MARK-UP

P2 For S73 P1 For Planning STATUS REVISION	13/12/2021 05/03/2021 DATE	DRAWING STATUS PLANNING		CLIENT Vine 1 & Vine 2 Ltd PROJECT 22-26 Vine Hill
		DRAWING FILE REF 1134_PL-GA-00.vwx DRAWN BY WH REVISION P2		
DRAWING PROPOSED PLANS		SCALE 1:50 @ A1 (1:100 @ A3)	DATE March 2021	Buckley Gray Yeoman Studio 4.04 The Tea Building 56 Shoreditch High Street London E1 6JJ T: 020 7033 9913
DWG No. 1134_PL-GA-00

1 Proposed Plan - Courtyard
1:50 @ A1

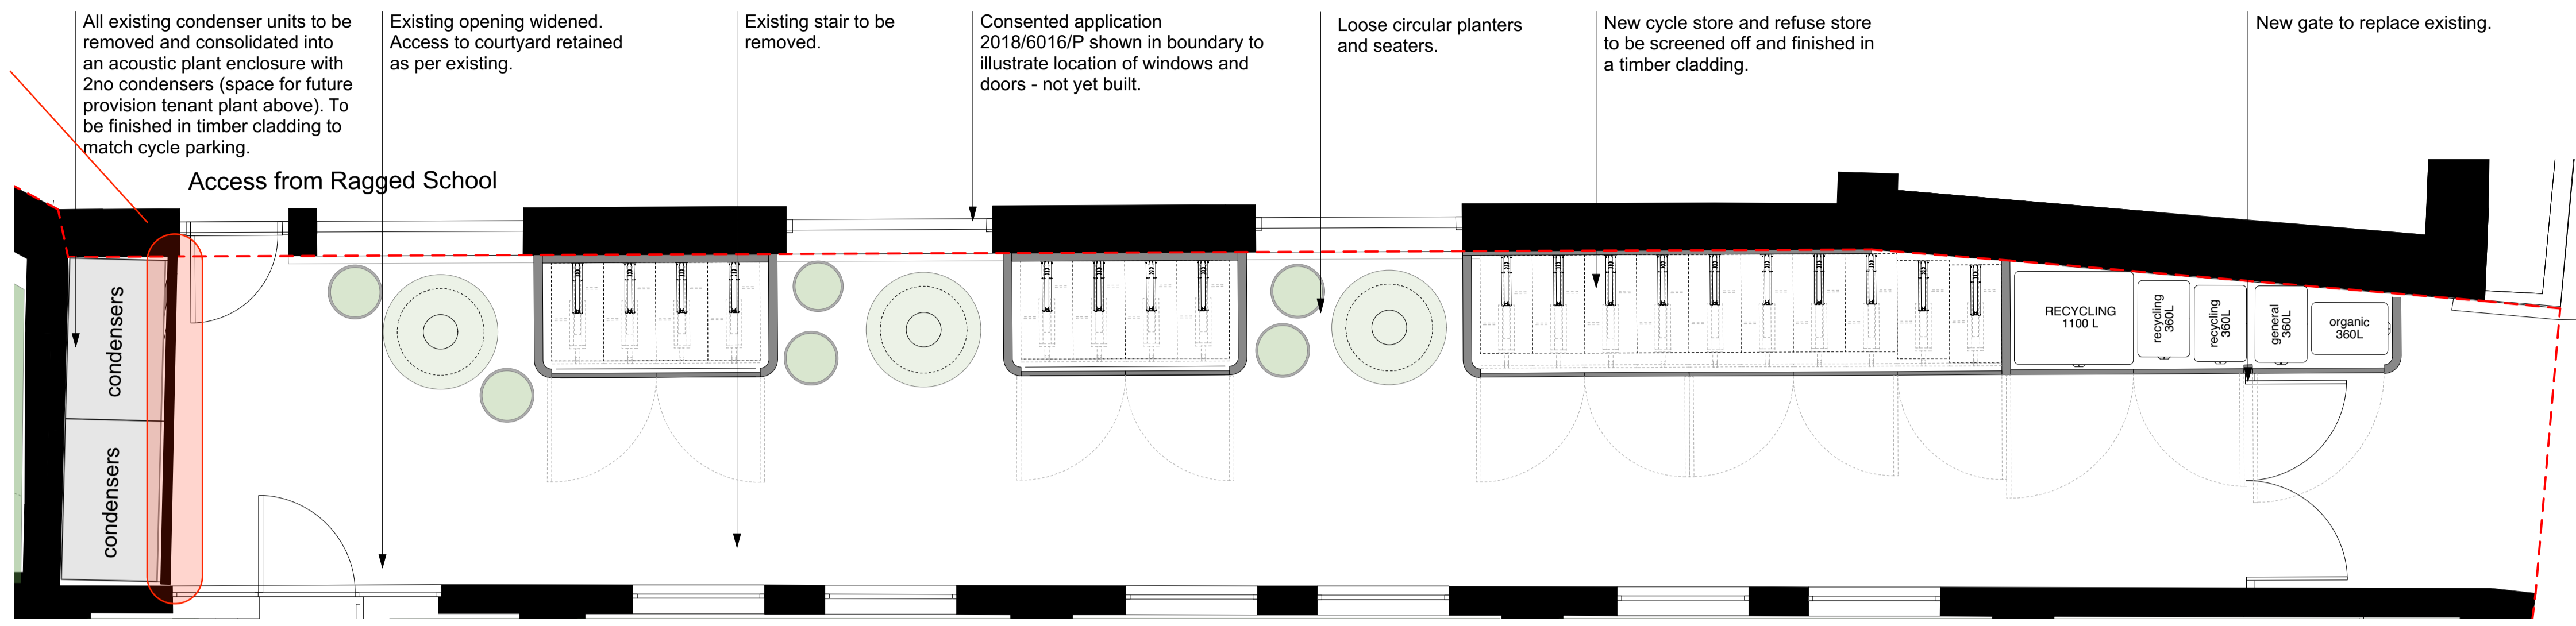
Increased attenuating enclosure (Future provision plant shown)
Please note quantum of condensers unchanged - 4no condensers in yard outlined previously, please refer to acoustic assessments.

Minor access changes and Future provision Tenant Plant indicated

2 Proposed Plan - 7 Warner Yard Roof
1:50 @ A1

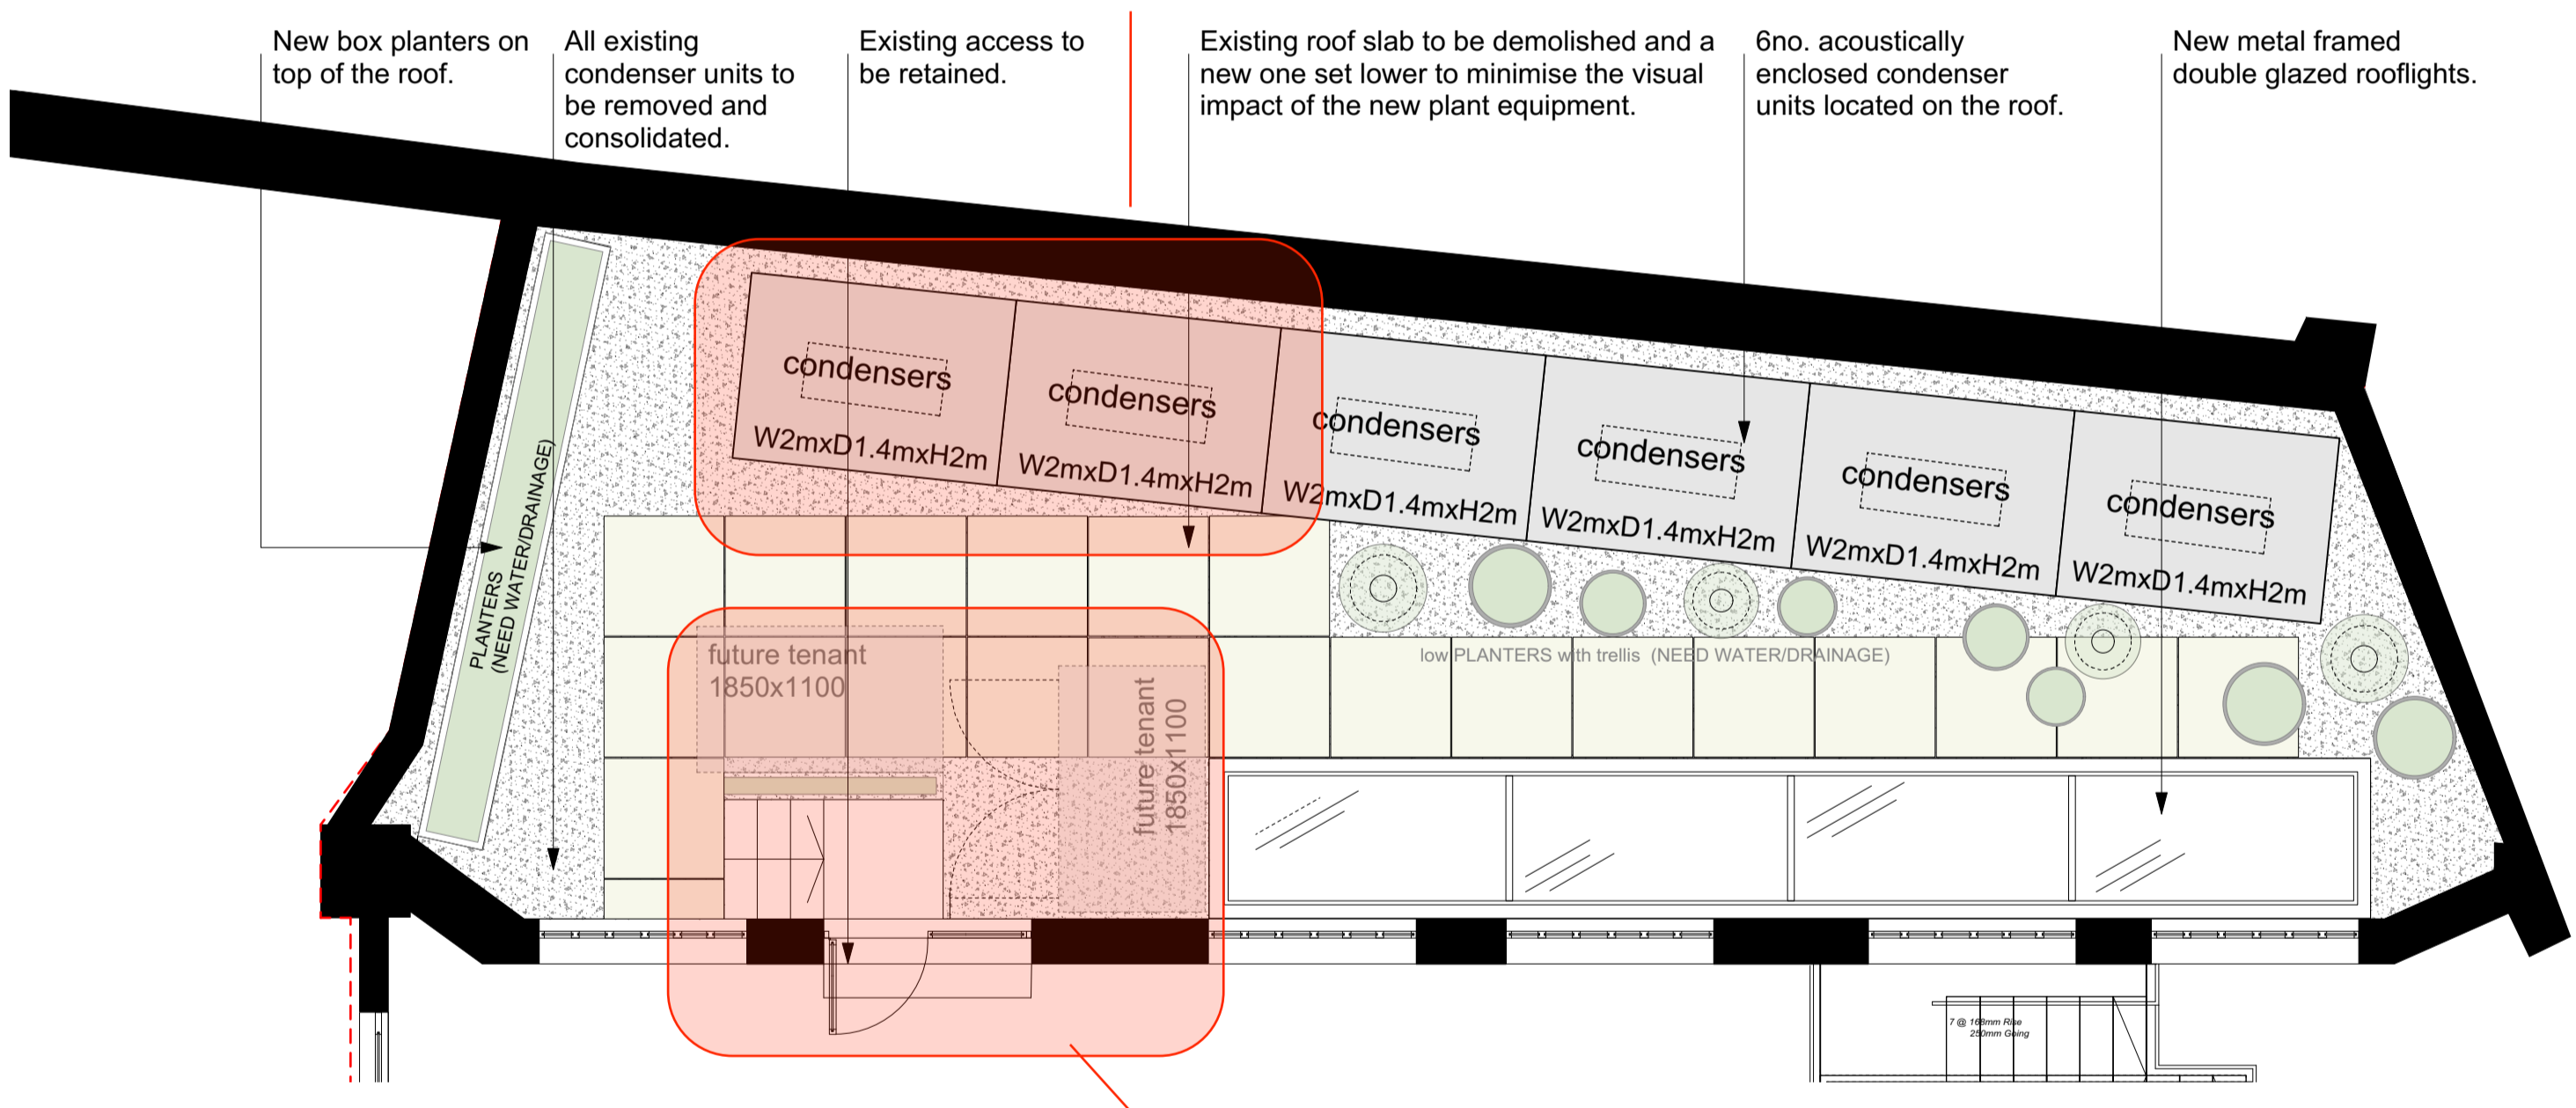
6no roof condensers shown instead of 4no.
